GRAND-BECK DEVELOPMENT JSP25-05

Public hearing at the request of Gratus, LLC for approval of Preliminary Site Plan, Wetland Permit, Woodland Permit, and Stormwater Management Plan. The subject properties, located at 47277 Grand River, comprise approximately 3.70 acres. The site is located east of Beck Road, south Grand River Ave (Section 16), and is zoned B-3 District. The applicant proposes to develop the site with a fuel station, convenience store, and car wash.

PRELIMINARY SITE PLAN

C-4.2

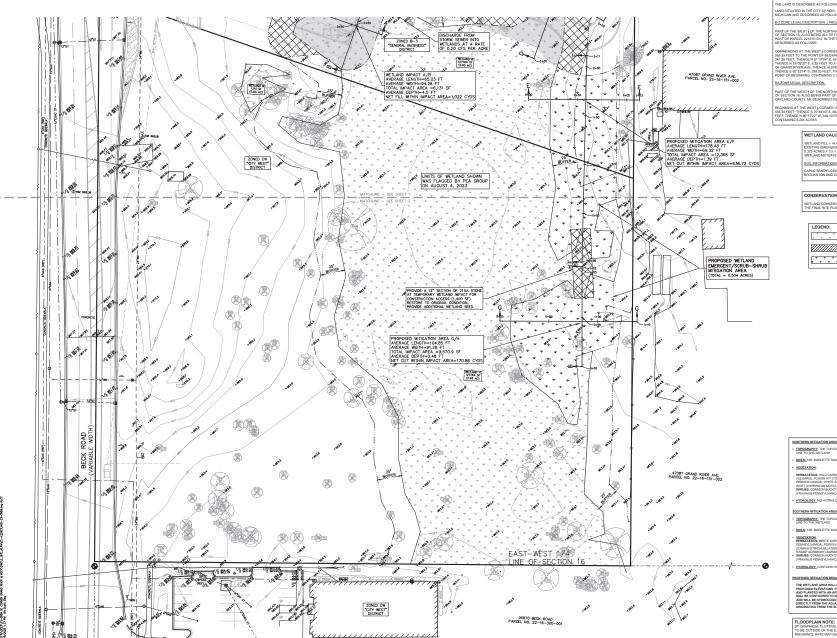
- The applicant has provided callouts for impact cross-sections A/B and C/D on Sheet C-4.2. Merjent understands that these cross-sections may include areas extending outside the wetland boundary. However, the total square footage for these impact callouts is 14,828 square feet (8,152 [C/D] + 6,676 [A/B]), which is 777 square feet more than the total stated permanent wetland impact (14,051 sq. ft.) stated at the top of Sheet C-4.2. The applicant is requested to clarify these impact callouts to ensure that these callouts equal the total impact for wetland areas.

- This would also apply to any cubic yard calculations/totals for the callouts compared to the total proposed wetland fill.
- The applicant should clarify the proposed temporary wetland impacts. It is understood that the proposed temporary impacts are for construction access. The applicant should clarify how this temporary impact will be accomplished, i.e., grading, matting, temporary fill, etc. Cross Section F on Sheet C-4.4 implies that fill will be placed to accomplish this temporary construction access.

- The applicant should clarify the fill material(s) that will be used for the wetland fill (topsoil, 21AA stone, sand, concrete, etc.).
- These requested edits/clarifications have been corrected on Sheets C-4.2 and C-4.3.

- The wetland mitigation is proposed on site, the mitigation plans are included on sheets C-4.2 and C-4.3
- A brief description of existing conditions at the proposed mitigation site. Existing conditions include but are not limited to, general topography, soils, vegetation, and any existing hydrology.

- a) Please see sheets C-4.2 and C-4.3 for changes.
- 6) **Requested action:** The applicant should display on future plans where conservation easements will be placed and the type of signage that will be used around (at a minimum) the proposed mitigation area.

L-1.0

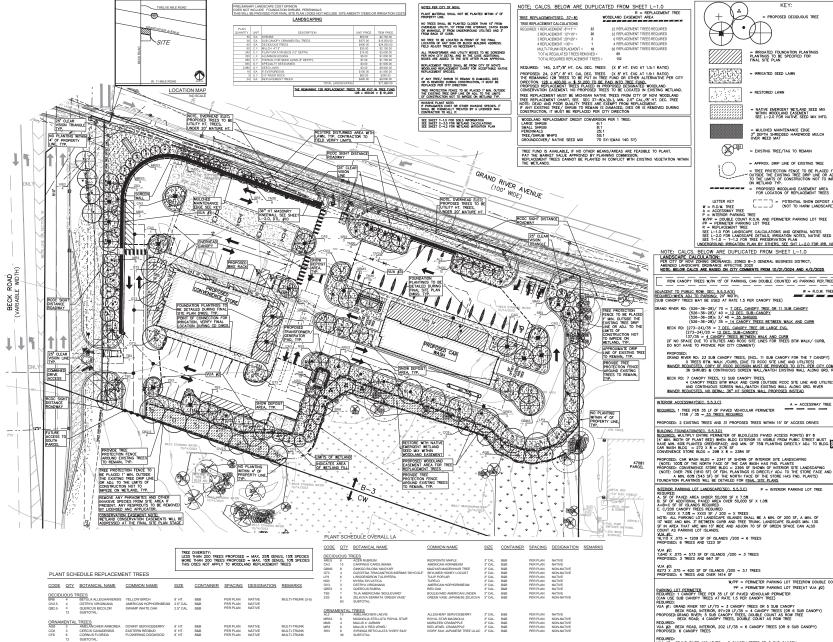
- b. A waiver is granted for deficiency in building foundation landscaping for the convenience store, under Zoning Ordinance Section 5.5.3.D.ii.b 75% required, 69% provided. The deviation is not significant, and the proposed landscaping is sufficient.

T-1.0

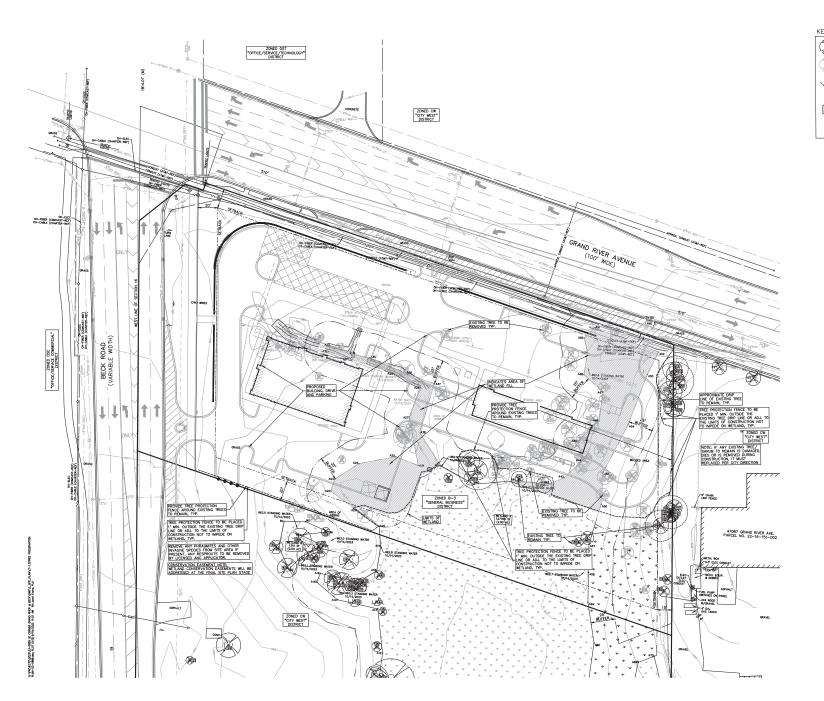
The applicant should revise the replacement table to reflect the correct amount of multi-stem trees
to be removed. Additionally, the plan currently states (Sheets L-1.1 and T-1.0) "4 Replacement:
 <30" and should instead state "greater than (>)."

- a) Please see changes to the Tree Replacement table on Sheet L-1.0 & L1.1
